**PLAN MODIFICATION – NOTICE OF HEARING**

Applicant	BEI Group Limited
Plan modification number	Plan Modification 59
Application description	to rezone approximately 13.72 ha of land from Residential – Mixed Housing Suburban to residential – Terraced Housing and Apartment Buildings. It also seeks to amend Albany 9 precinct provisions and to introduce a new Albany 10 Precinct within the Auckland
Site address	Albany 10 Precinct

**IN THE MATTER** of **Private Plan Change 59** – Albany Precinct 10 to the Auckland Unitary Plan

**MEMORANDUM OF COUNSEL ON BEHALF OF BEI GROUP LIMITED  
– RESPONSE TO HEARING PANEL DIRECTION #1**

**Figure I522.6.32.1 Maximum building dimension plan view**

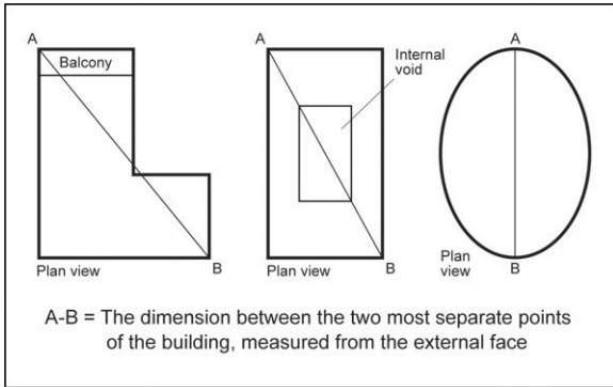
**Commented [AC71]:** 73.48 – Supported for clarity.

**Figure I552.6.45.1 Building coverage and setback at upper levels**

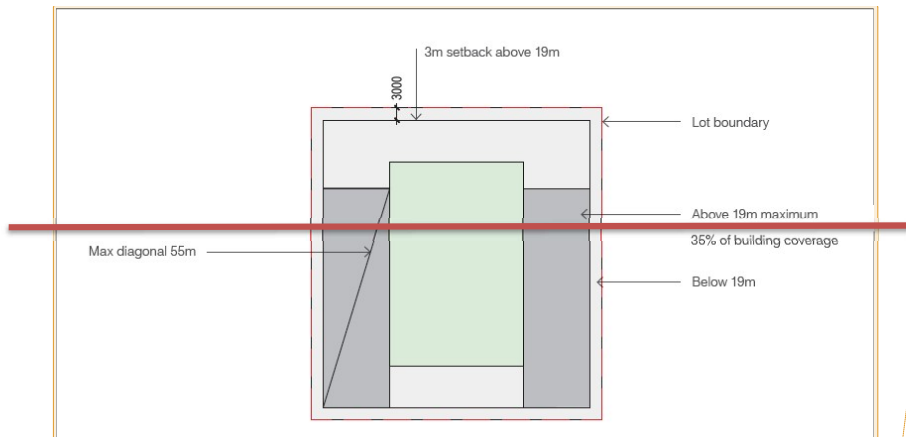
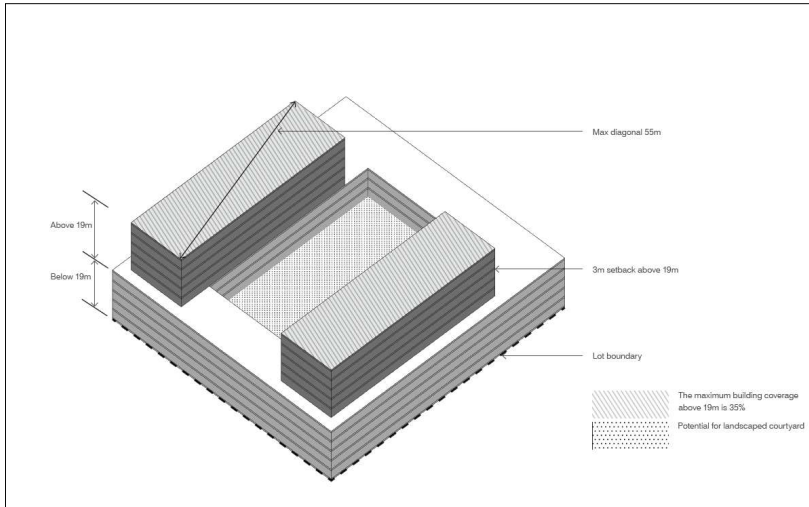
**Commented [AC79]:** 73.51 – Opposed in part to 6m upper-level setback.

**Commented [AC80]:** 73.51 – Figure deleted. Amended figure without colour and explanatory graphic in 3D included for interpretative ease.

Amended figure without colour and explanatory graphic in 3D included for interpretative ease.

# Precinct Plan 2

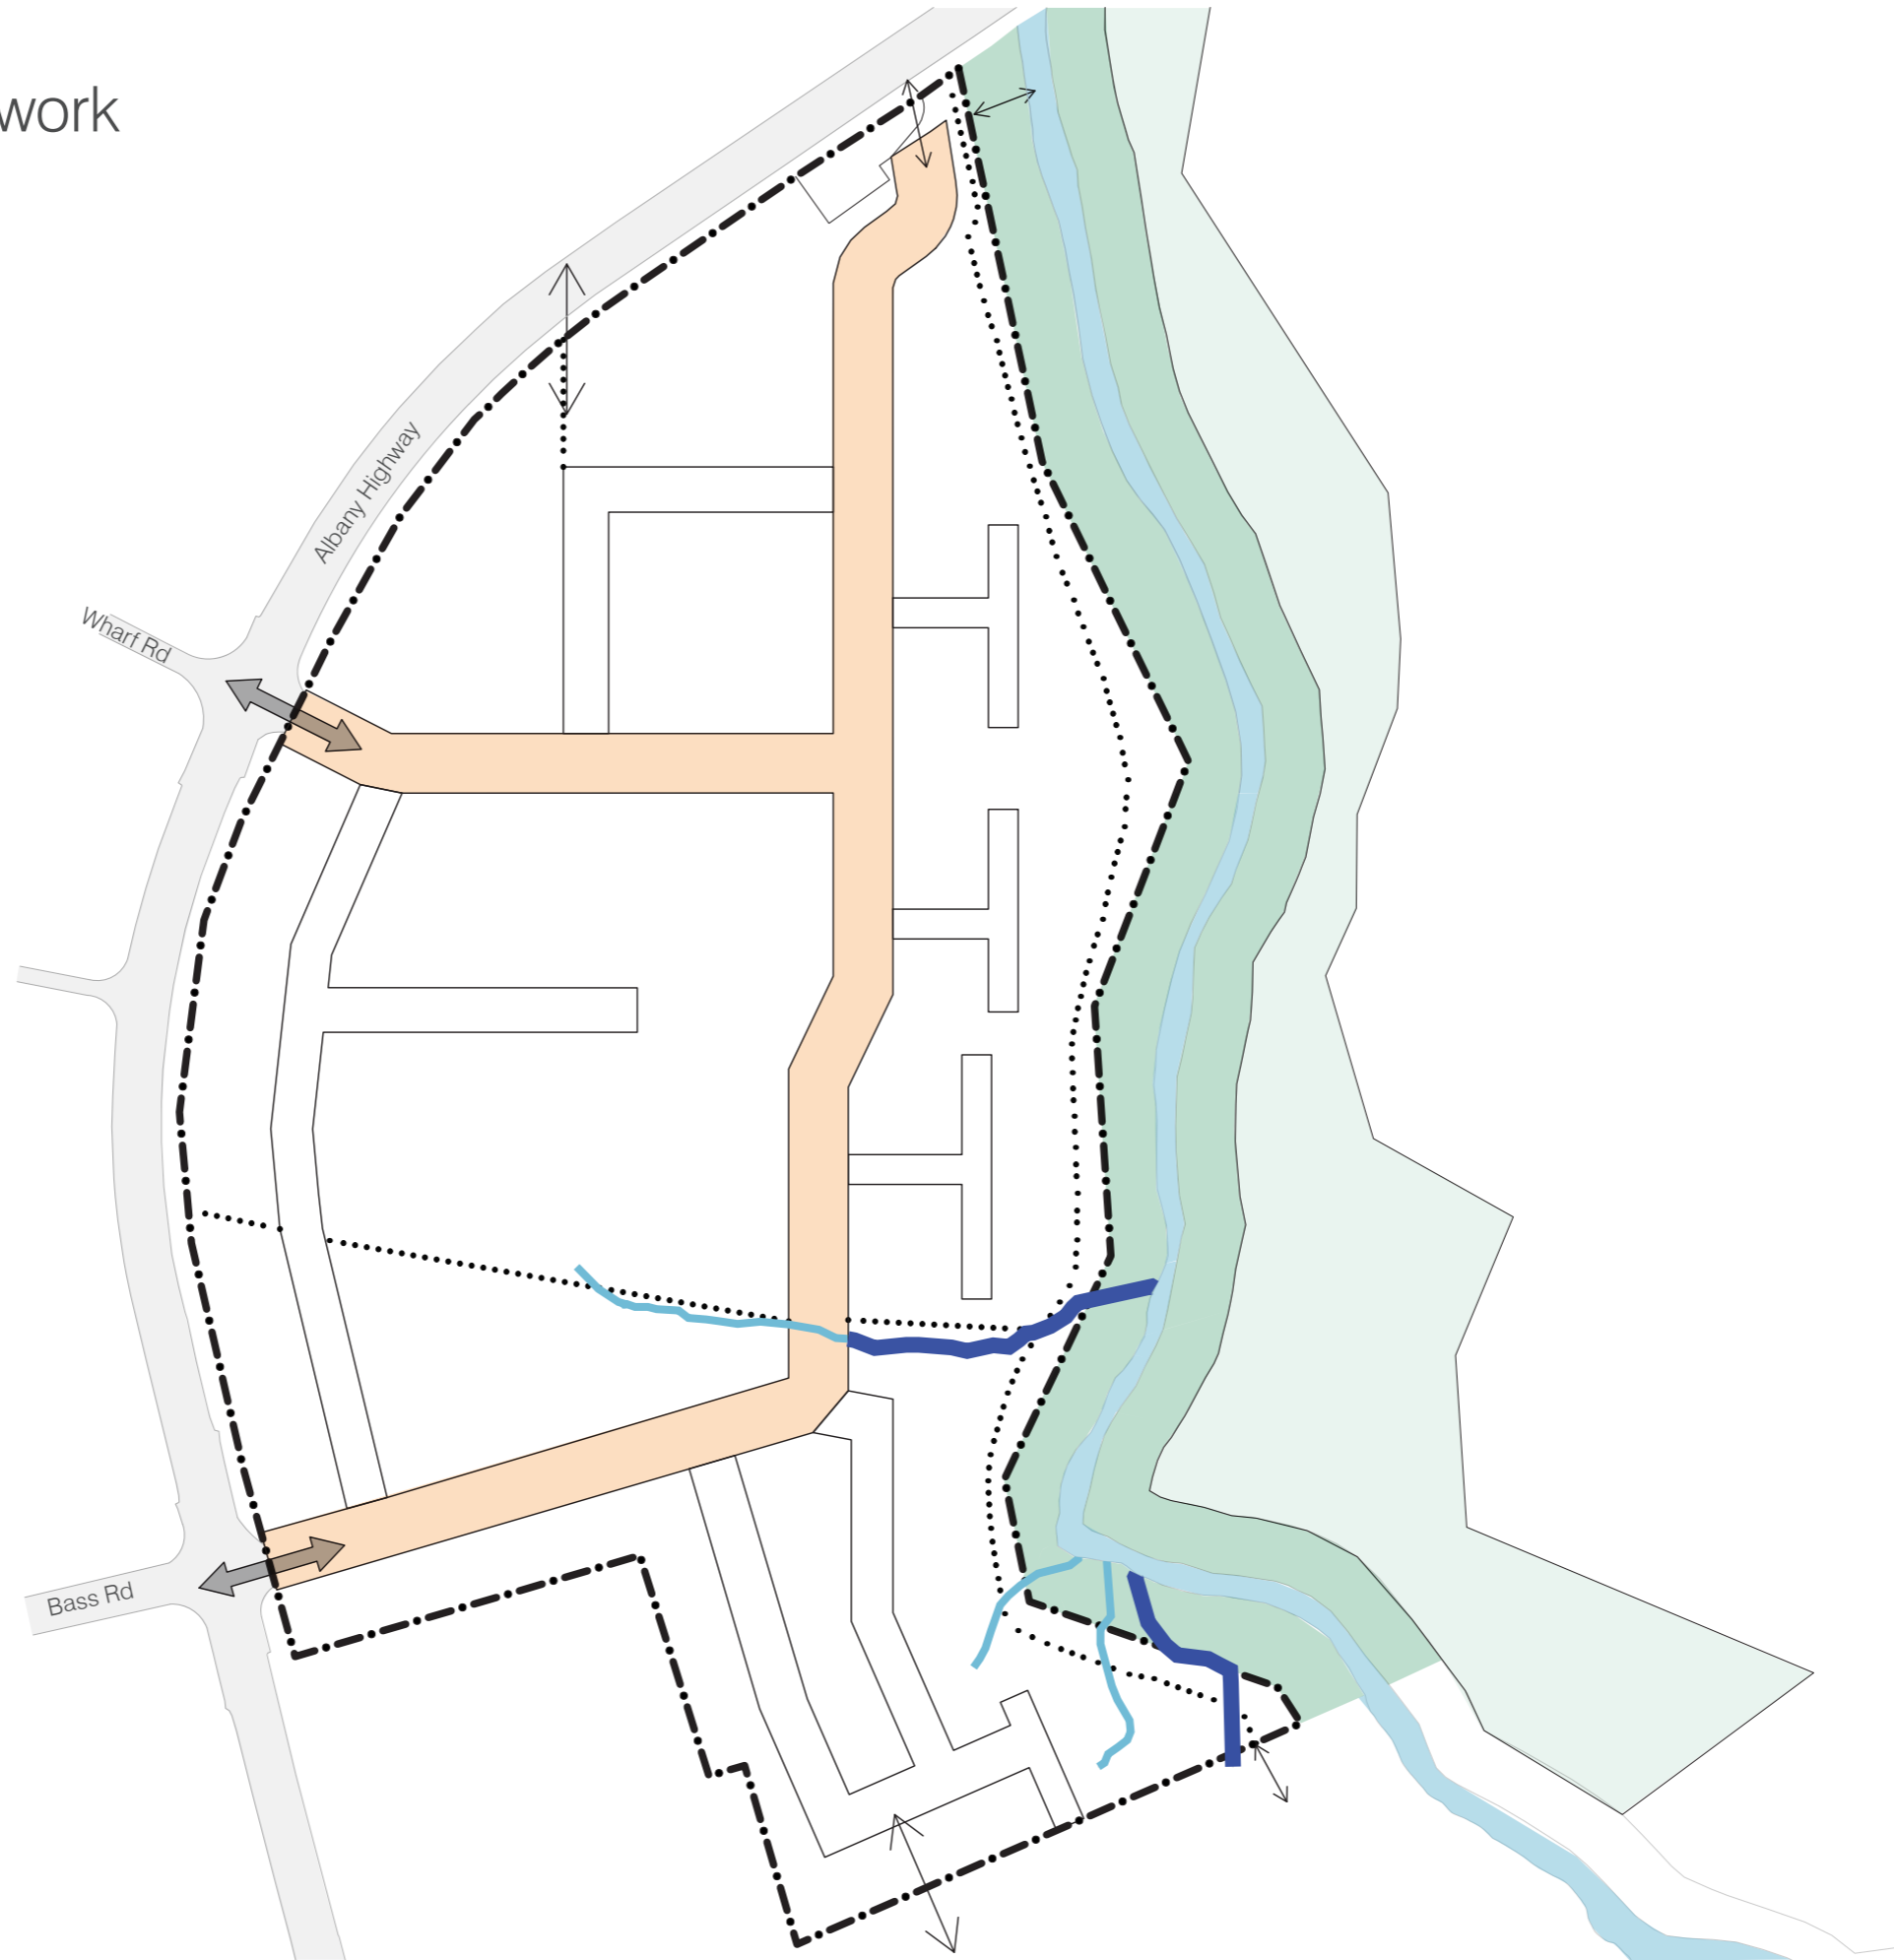
**Commented [AT126]:** 127.40 – Supported. Requested deletion of the northern vehicle access with amended precinct plans. Now provides for pedestrian/cycle connection only.
